INDESIT company

Model type:
AVXXF149EX

Commercial code:
F033728

1200110B Exploded views

n4008c02: Rear drum replacement

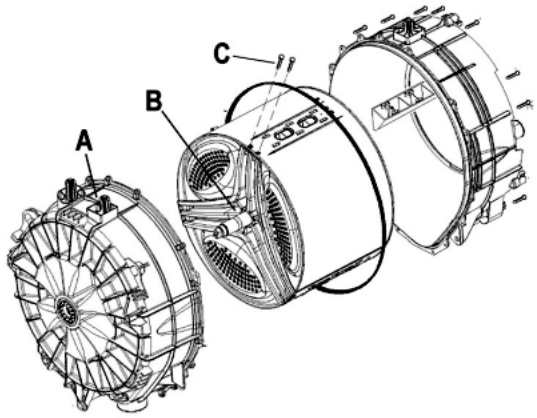
All drum service replacements use 35mm bearings

When you use in assistance the rear drum you will also need to change the drum bearing spider from the 30mm version to the 35mm version

A = C00119357 Drum Rear
B = C00117329 Drum Bearing Spider
C = C00201310 Drum Bearing Spider screws (Qty 6)

Production use 3 screws but for Service we suggest that 6 screws are used.

n0508c01: Door Gasket Clamp Band

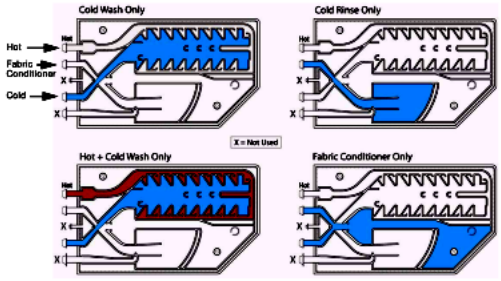
A New Polypropylene Gasket clamp band has been introduced in production from Serial number 80325.0000
The purpose is to provide added support to the inner rim of the door gasket.
